ECE/TRANS/WP.29/GRRF/2005/11/Rev.1
21 November 2005

World Forum for Harmonization of Vehicle Regulations (WP.29)

REVISED PROPOSAL FOR DRAFT AMENDMENTS TO REGULATION No. 117 */

(Tyre rolling sound)

Example 1, amend to read:

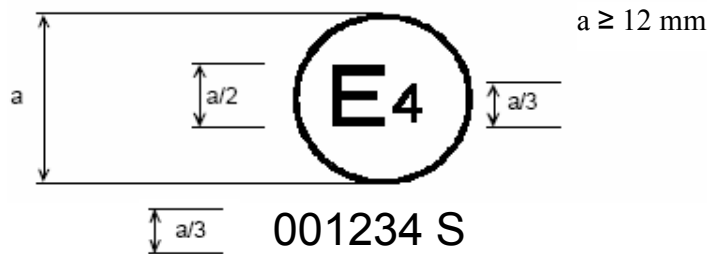
The above approval mark, affixed to a pneumatic tyre shows that a tyre concerned has been approved in the Netherlands (E4) pursuant to Regulation No. 117 (marked by **S (rolling sound)** only), under approval number 001234. The first two digits of the approval number (00) indicate that the approval was granted according to the requirements of this Regulation in its original form."

Example 2, amend to read:

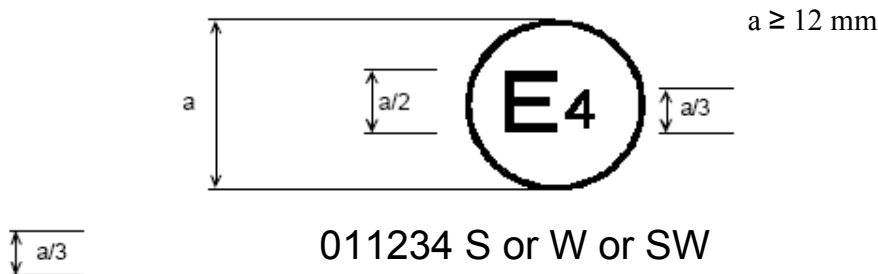
The above approval mark shows that the tyre concerned has been approved in the Netherlands (E4) pursuant to **Regulation No. 117 (marked by S (rolling sound) or W (wet adhesion) or both SW), under approval number 011234. This indicates that the approval is for S (rolling sound), W (wet adhesion) or both SW. The first two digits of the approval number (01) indicate that the approval was granted according to the 01 series of amendments.**"

Example 3, amend to read:

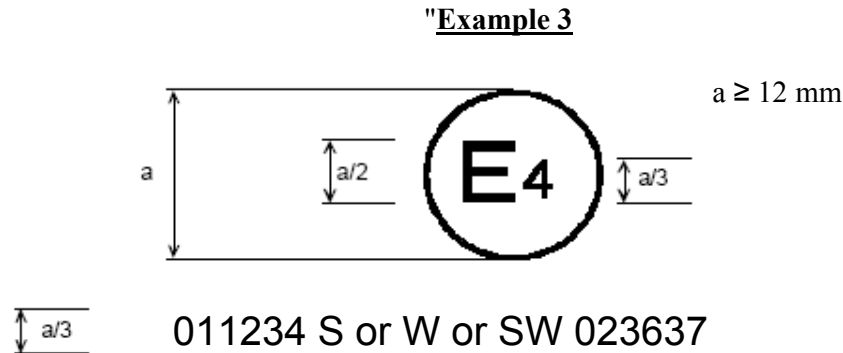
The above approval mark shows that the tyre concerned has been approved in the Netherlands (E4) pursuant to Regulation No. 117 (marked by **S (rolling sound) or W (wet adhesion) or both SW**), under approval number **011234**. This indicates that the approval is for **S (rolling sound), W (wet adhesion) or both SW**. The first two digits of the approval number (01) indicate that the approval was granted according to the 01 series of amendments, *but Regulation No. 30 included the 02 series of amendments.*"

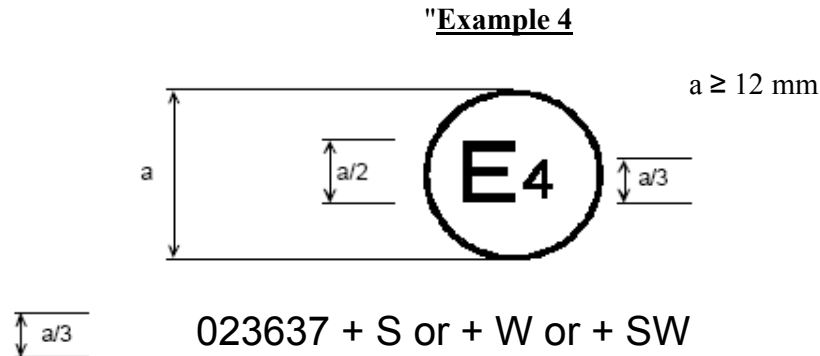
The above approval mark shows that the tyre concerned has been initially approved in the Netherlands (E4) pursuant to Regulation No. 30 and the 02 series of amendments under approval number 023637. It is also marked by +S or +W or both +SW which indicates that it has had its approval extended under Regulation No. 117. This indicates that the approval is for S (rolling sound), W (wet adhesion) or both SW. The first two digits of the approval number (02) indicate that the approval was granted according to Regulation No. 30 which included the 02 series of amendments. The addition (+) sign indicates that the first approval was granted in accordance with Regulation No. 30 and has been extended to include Regulation No. 117 approval(s).

Example 5

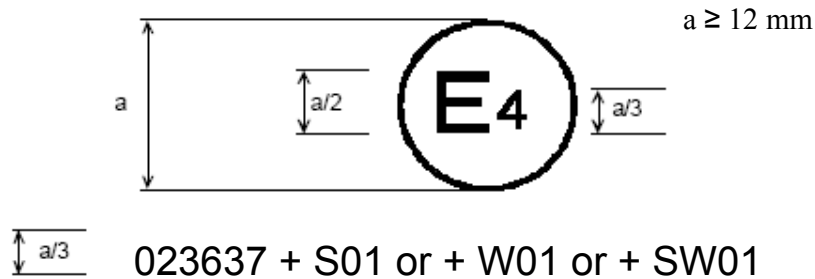
The above approval mark shows that the tyre concerned has been initially approved in the Netherlands (E4) pursuant to Regulation No. 30 and the 02 series of amendments under approval number 023637. This indicates that the approval is for S (rolling sound), W (wet adhesion) or both SW. The S, W or SW followed by (01) indicates that it has had its approval extended under Regulation No. 117 which included the 01 series of amendments. The first two digits of the approval number (02) indicate that the approval was granted according to Regulation No. 30 which included the 02 series of amendments. The addition (+) sign indicates that the first approval was granted in accordance with Regulation No. 30 and has been extended to include Regulation No. 117 approval(s).

Example 6

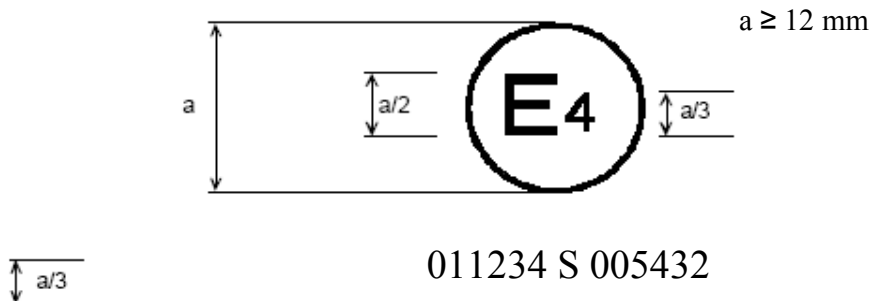
The above approval mark shows that the tyre concerned has been approved in the Netherlands (E4) pursuant to Regulation No. 117 and the 01 series of amendments under approval number 011234 (marked by S only), and Regulation No. 54. This indicates that the approval is for rolling sound (S) only, as Regulation No. 54 approved tyres at present cannot be approved for wet adhesion. The first two digits of the Regulation No. 117 approval number (01) in conjunction with 'S' indicate that the first approval was granted in accordance with Regulation No. 117 which included the 01 series of amendments. The first two digits of Regulation No. 54 (00) indicates that this Regulation was in its original form.
